DeKalb County Historic Preservation Commission

Staff Report

H. 831 Clifton Road, Monty Dannenberg. Install dormers and modify windows. **1246926**

Renovation Plans For:
 the Residence at:
 831 Clifton Dr Northeast
 Atlanta, GA 3007A

Figure 2.1 (Proposed Steel Units Outlined in Red)

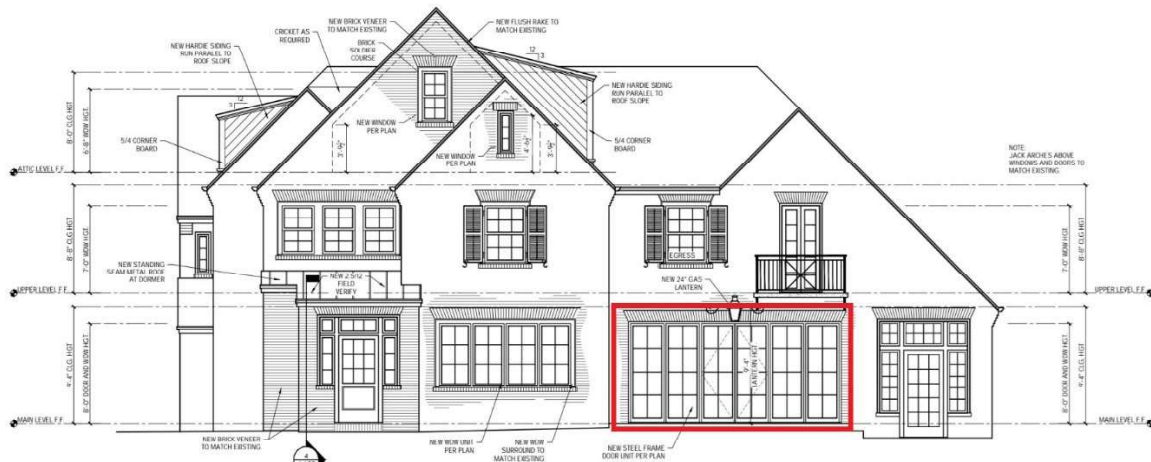
2) "Add steel fame door unit with window. "

Answer: We intend to replace current windows/doors on the back of the house with a steel unit to provide more light and better access to the back yard. (See Figures 1.1 & 1.2) The steel windows/door materials are currently existing in the "sun room" of the home, which also faces the back yard. We intend to recreate those doors/windows, with identical materials so that there is a cohesive look on the first floor of the home. Please see images below. Windows will be constructed by Brian Womack of Womack Ironworks. Womack Iron has also created similar windows and doors for several other Druid Hills historic homes as approved by the committee, including keystone properties of 845 Clifton and 841 Clifton. Please see photos below for reference.

Figure 3.1 (Proposed Windows are Outlined in Red and Orange. The Proposed Window Outlined in Orange will be Matched to the Existing Window Outlined in Blue. The Proposed Window Outlined in Red will be Matched to the Existing Window Outlined in Green on Figure 3.2)

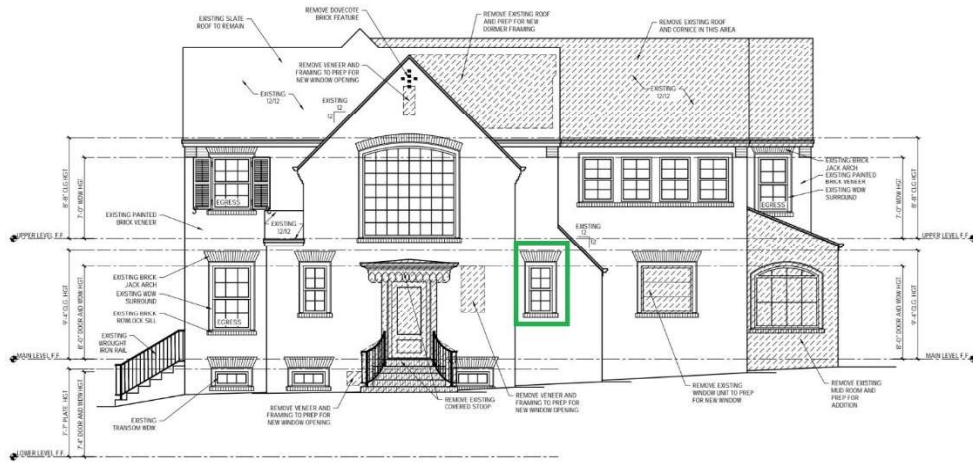
Answer: Similar to number two above. Our intent is to create more light on the first floor of the home, and to provide easier access to the backyard. Additionally, instead of louvered openings for the attic, we will replace them with windows built to the exact match to the windows on the floor directly below them. (See Figure 3.1 & Figure 3.2)
